Salem Nuclear Generating Station, Units 1 and 2
Renewed Facility Operating License Nos. DPR-70 and DPR-75
NRC Docket Nos. 50-272 and 50-311

Hope Creek Generating Station
Renewed Facility Operating License No. NPF-57
NRC Docket No. 50-354

Subject: Emergency Plan Document Revision Implemented June 26, 2019

50.54Q Title: Emergency Plan Section 3, Rev. 30, Emergency Organization

**STATION RESPONSE WITH EXTERNAL INTERFACE
(FIGURE 3-2)
PAGE 2 OF 2**

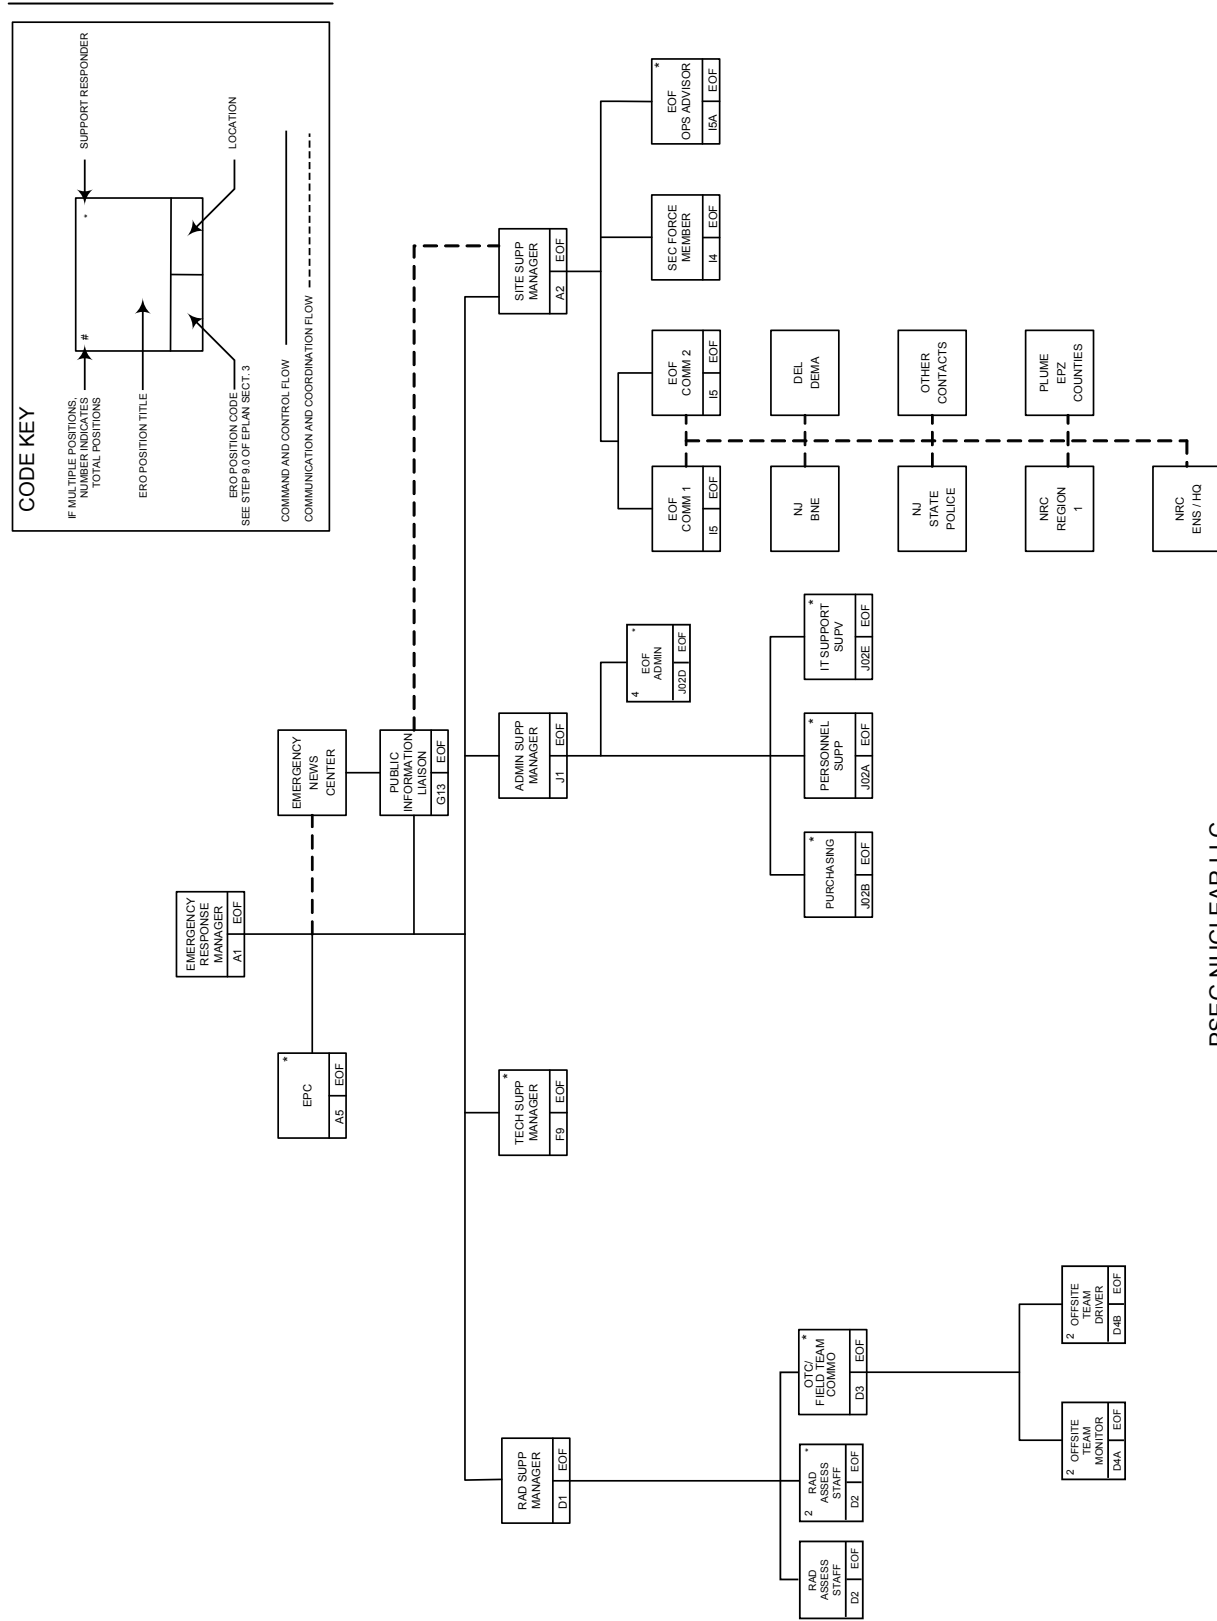
- Revised the following due to security organization changes – step 2.6, step 9.9 position titles and descriptions for positions I.1 and I.2, figure 3-2 position boxes for I.1 and I.2

- Figure 3-1 – added Note 2 to the HC OSC Coordinator box. Note was inadvertently omitted in Rev. 25
- Figure 3-2 – for readability, split Salem and Hope Creek into 2 pages, and deleted the notes that were associated with both stations appearing on the same page

- Figure 3-2 – updated various titles to match body of section 3
- Figure 3-3 – replaced box for “Material Control Supp” with “Purchasing” to reflect prior change

PSEG NUCLEAR LLC
 EMERGENCY OPERATIONS FACILITY
 EMERGENCY RESPONSE ORGANIZATION
 WITH EXTERNAL INTERFACE
 (FIGURE 3-3)

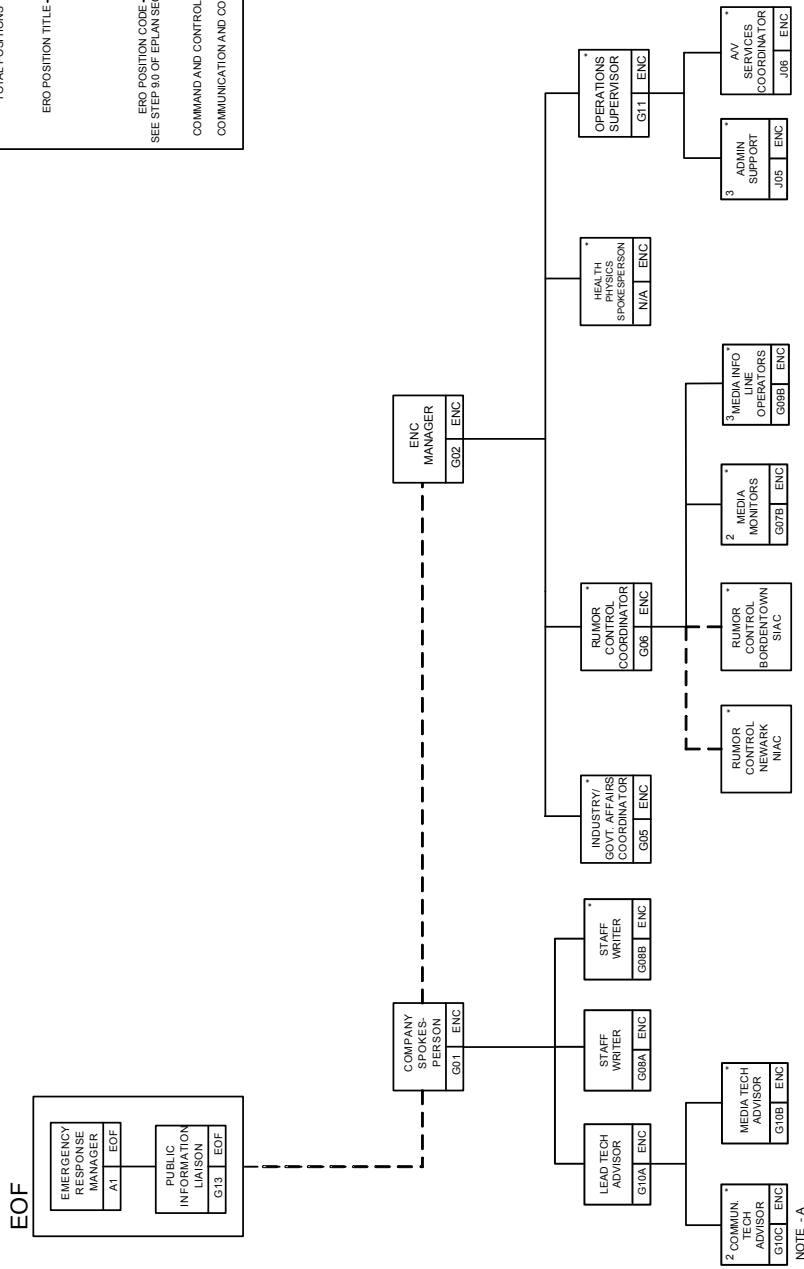
- Figures 3-1, 3-2, 3-3, and 3-4 – updated code key boxes
- Figure 3-1 and 3-2 – deleted RMC box, changed “Salem Hospital” to “Salem Medical Center”
 - Hospital update is per change to EPlan section 13, evaluated under 50.54(q) 2019-28
